GEOTECHNICAL AND GEOLOGIC HAZARD INVESTIGATION
The Ridge Nests Development
Powder Mountain Resort
Weber and Cache Counties, Utah

IGES Project No. 01628-008

Subject: Response to Review Comments
Geotechnical Investigation
The Ridge Nests Development
Powder Mountain Resort
Weber and Cache Counties, Utah

Subject: Response to Review Comments - Geology
Geotechnical Investigation
The Ridge Nests Development
Powder Mountain Resort
Weber and Cache Counties, Utah

Summit/Ridge Nests; A-A'; Static

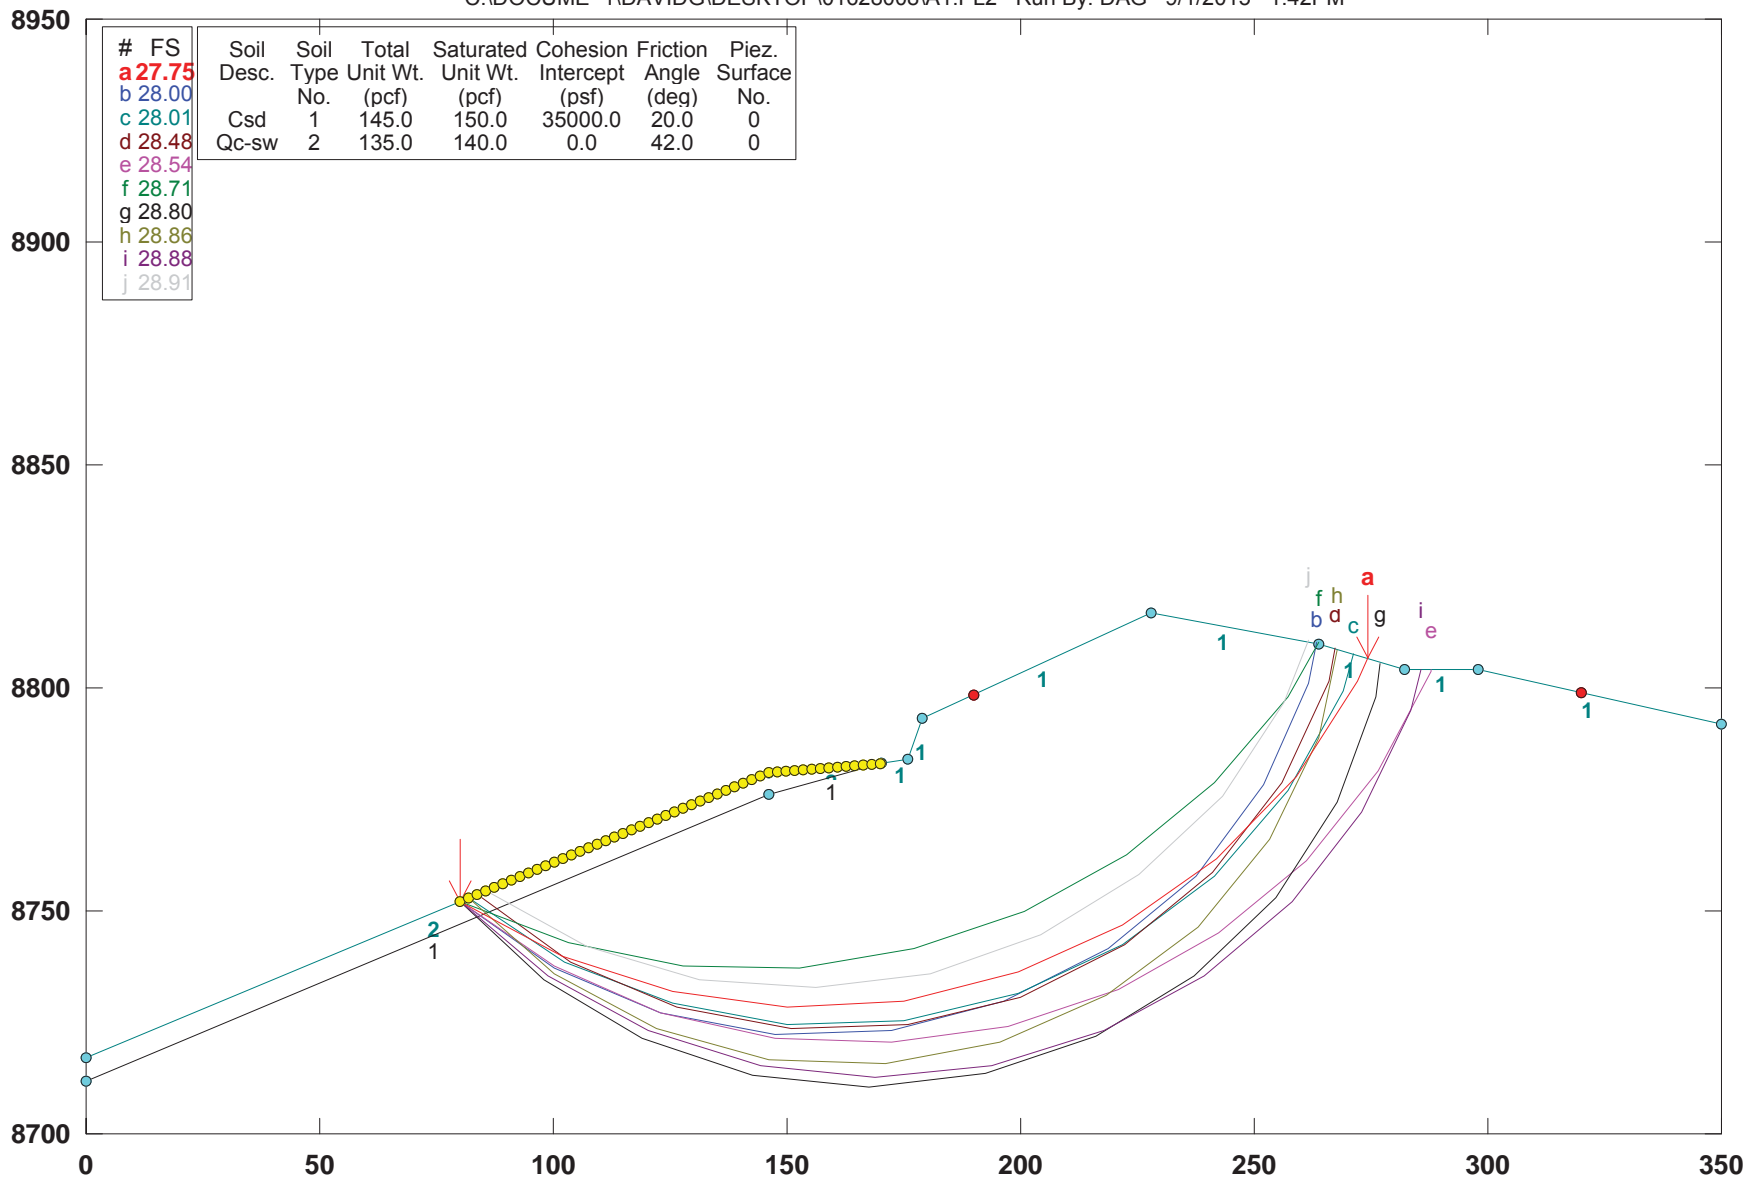
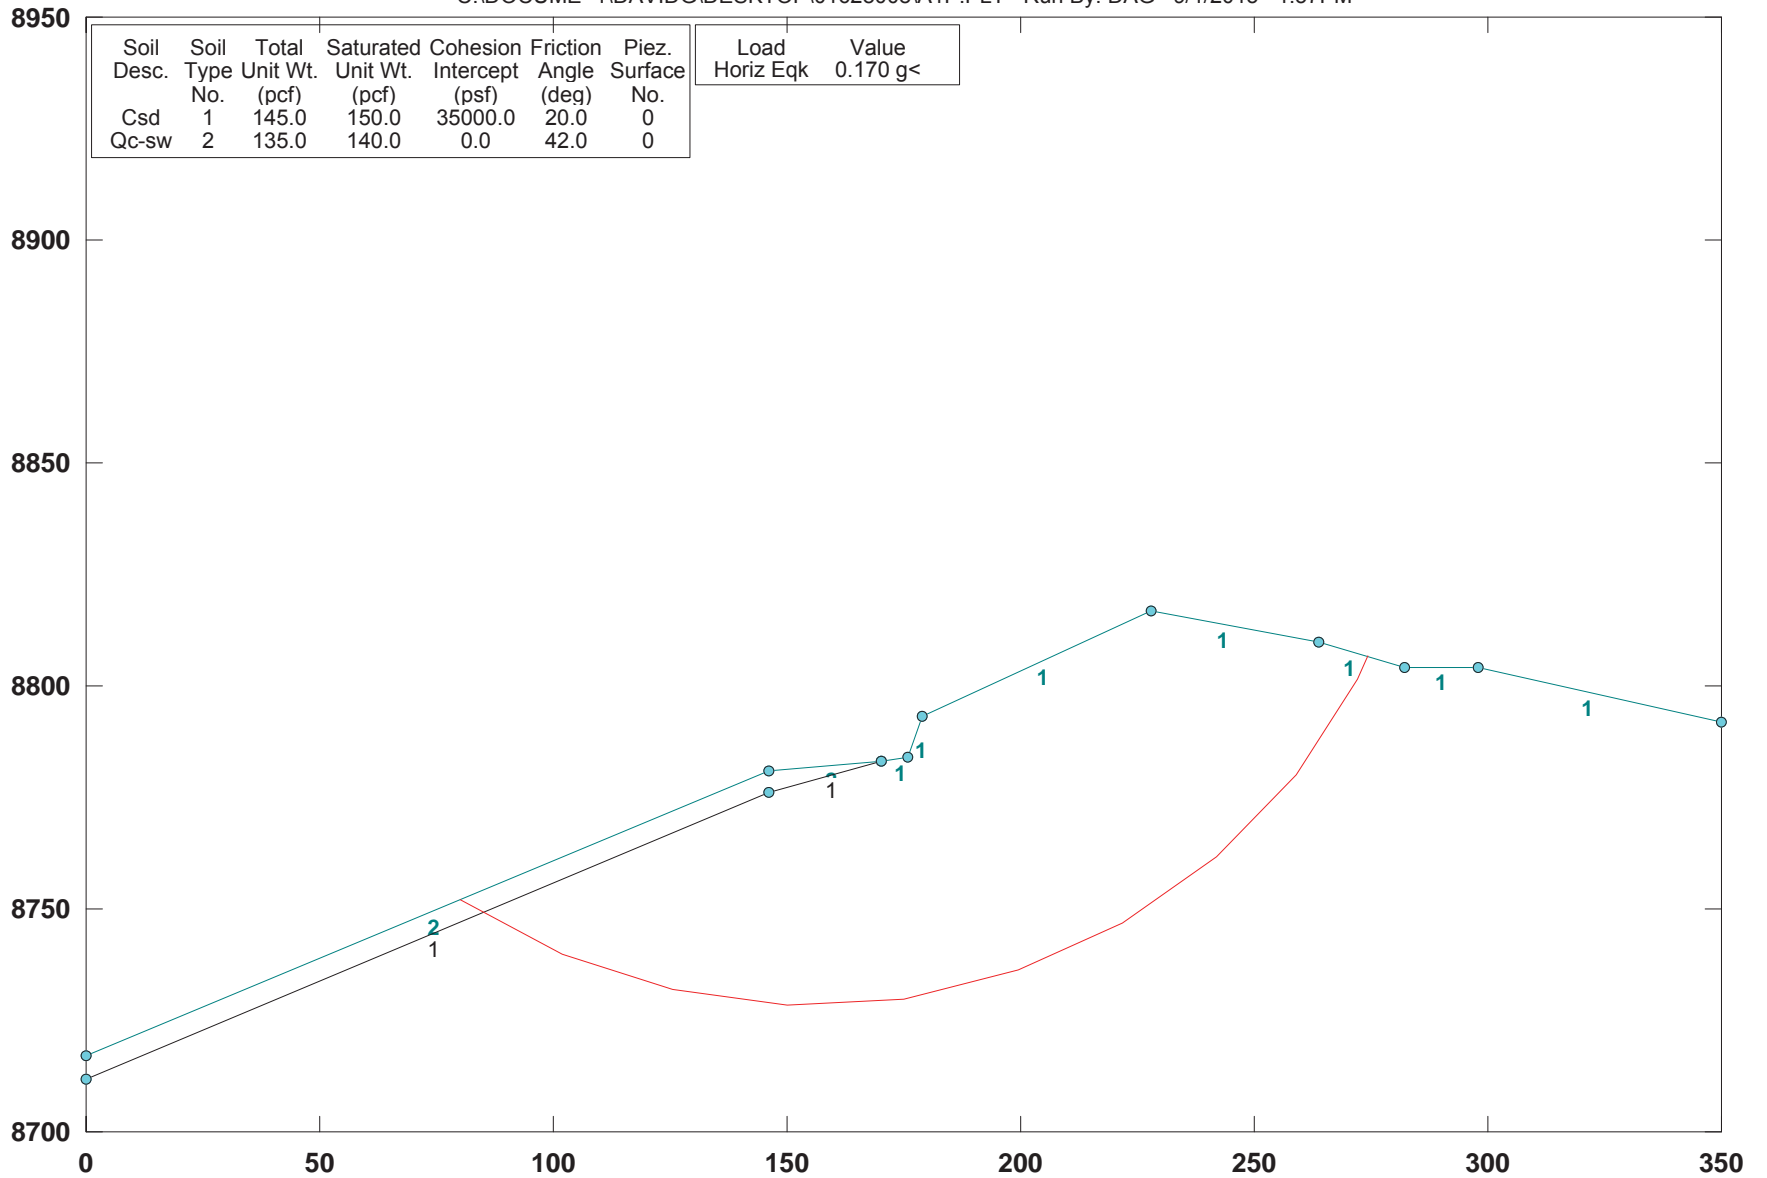
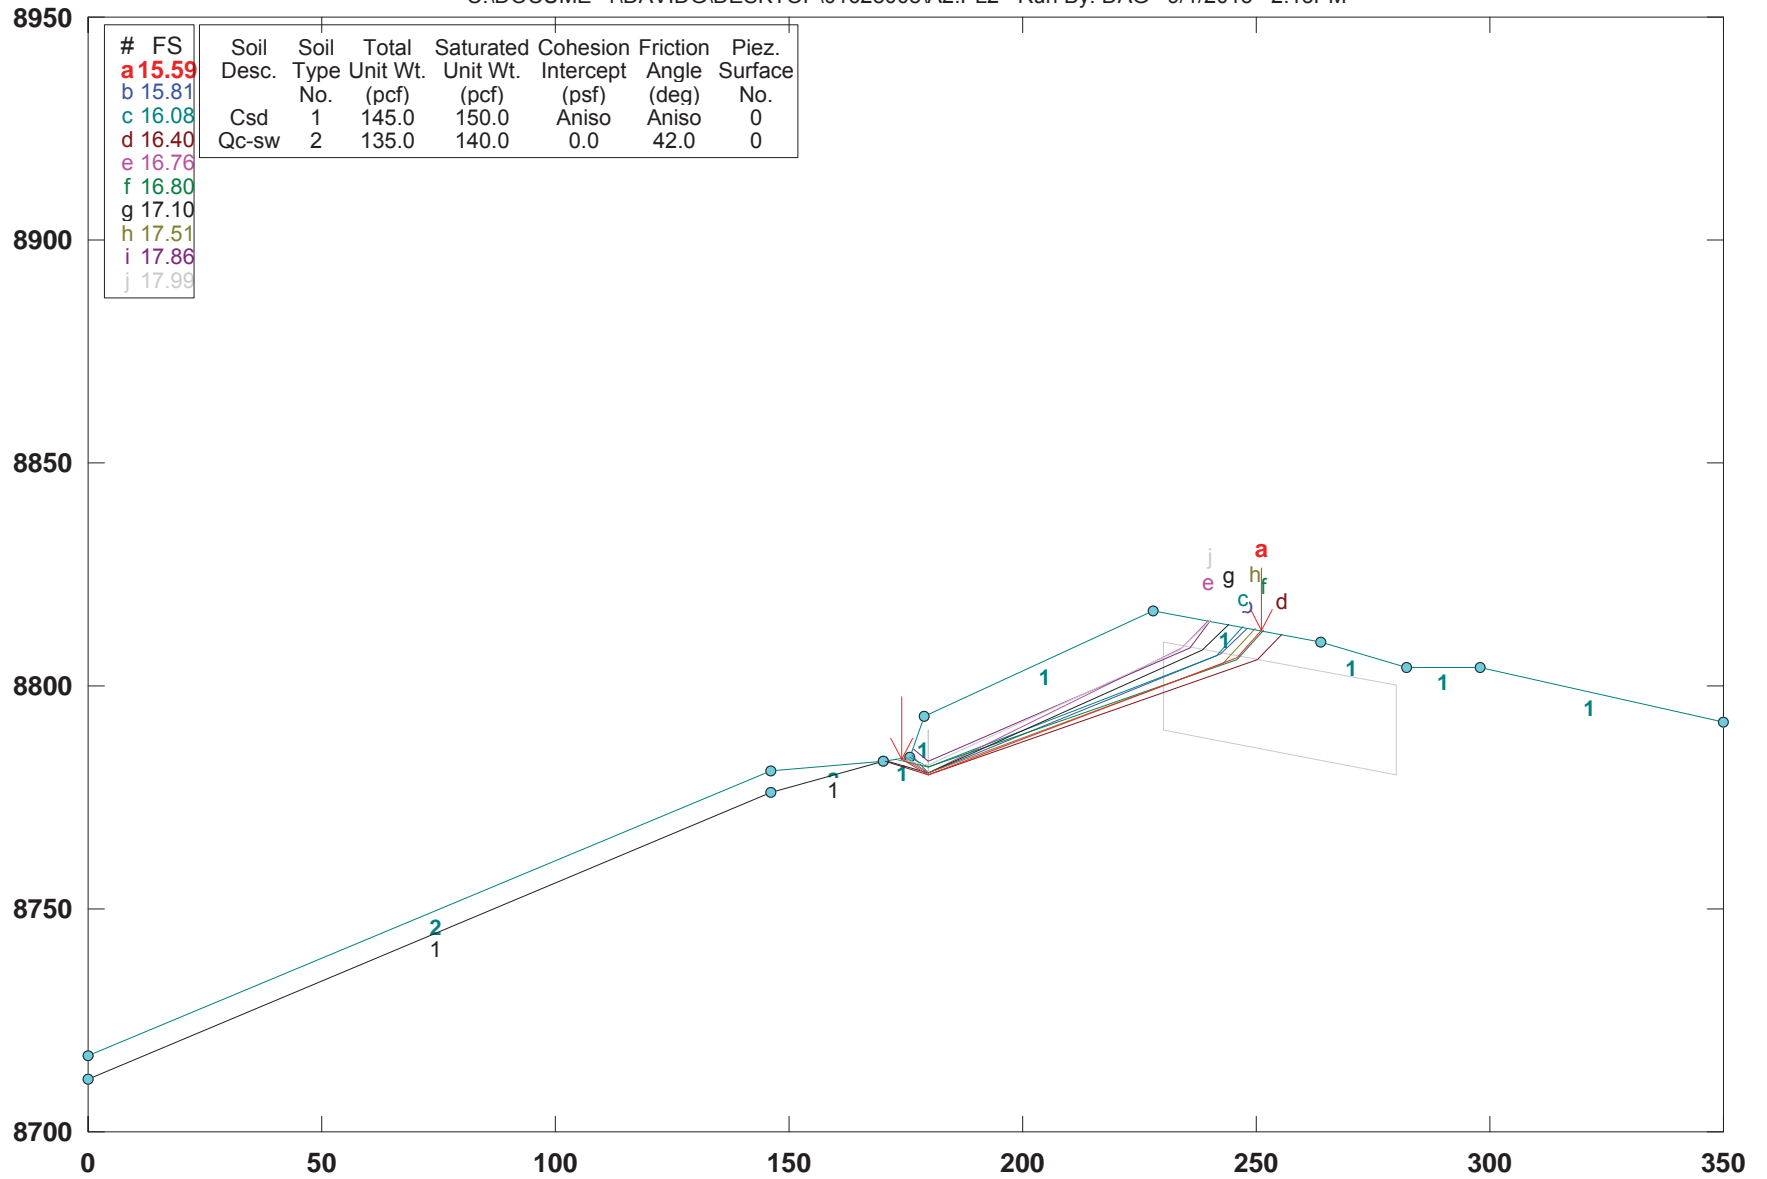
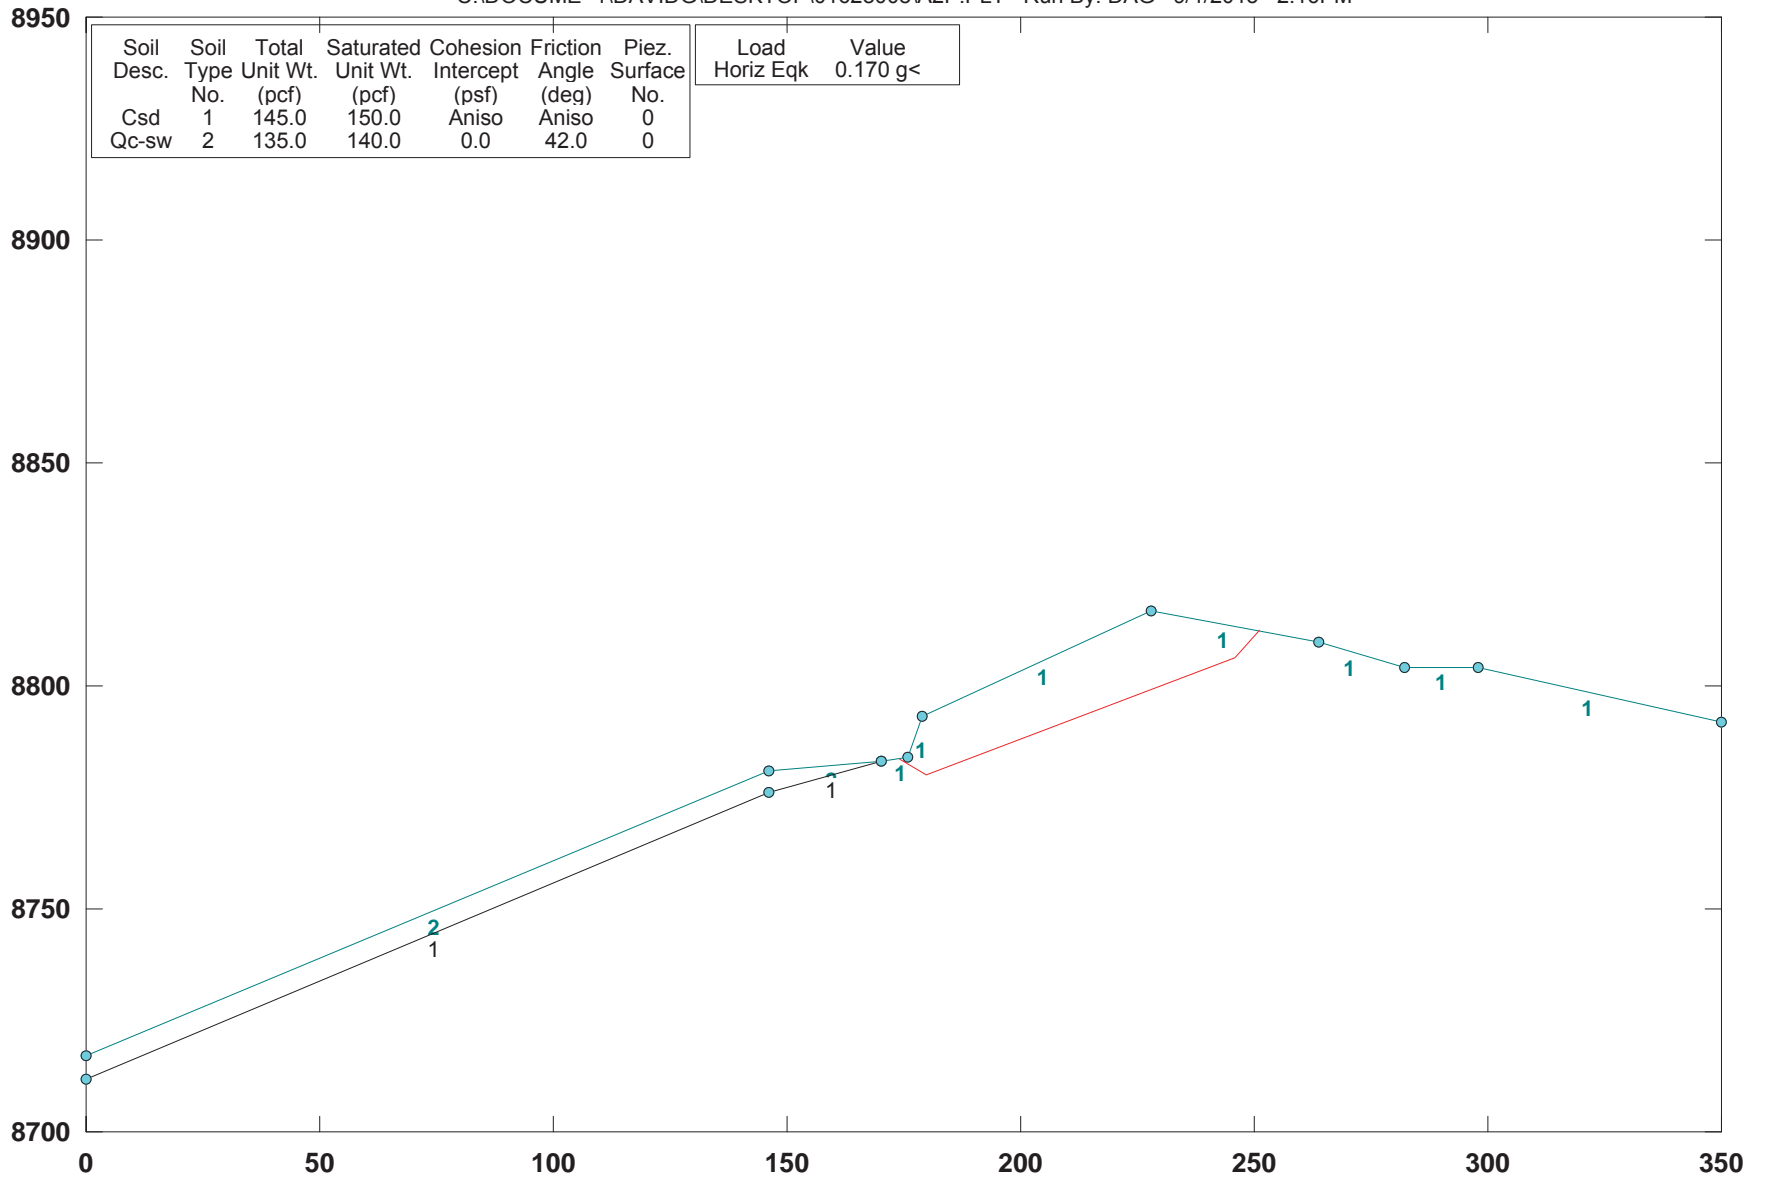
“The September 23, 2015, IGES response letter did not describe the properties of the bedding and/or jointing for incorporation into the slope stability analyses, e.g., properties such as, strike and dip, degree of fracturing (generally controlled by the number of joints in a given direction), persistence of jointing, spacing of jointing, roughness of joint surface, open and/or closed joints, joint coatings and infillings, etc.

The global stability of the slope was modeled using gSTABL7 slope stability software. Bishop’s Method and Janbu’s Simplified method was used to model the slope, as appropriate. For our analysis, we have assessed two representative sections, Section A-A’ and Section B-B’, illustrated on Plate 1 (*Geologic Map*) and the *Geologic Cross-Sections*, Figure 1, attached. Calculations for stability were developed by searching for the minimum factor-of-safety for both a circular-type failure and a block-type (translational) failure. For the circular analysis model, arcuate failure surfaces and homogenous earth materials were assumed. For the block analysis, anisotropic strength parameters in the bedrock was assumed, based on the apparent dip of bedding. A minimum static factor-of-safety of 1.5 and seismic factor-of-safety of 1.0 (global stability) was considered acceptable for this project considering the available information and design assumptions.
